Safety Recall

Code: 66K8

Subject Rear Wheel Arch Trim

Release Date October 22, 2019

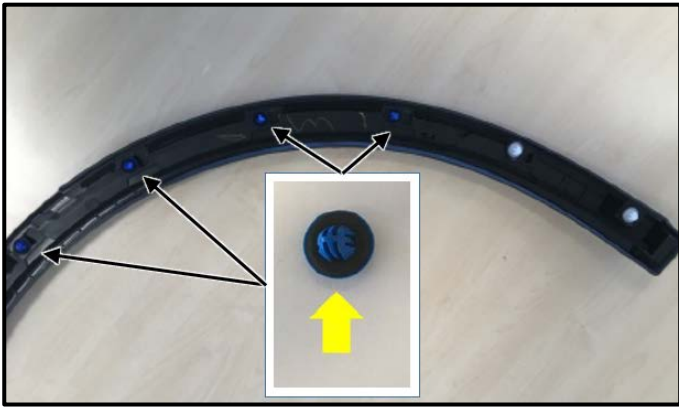
- Remove the old blue clips by sliding them down in direction of <arrows>.

Only the lowest two clips are being replaced.

- Install the new white clips in the opposite direction of removal.

Part Number	Part Description
WHT.008.801	Clip
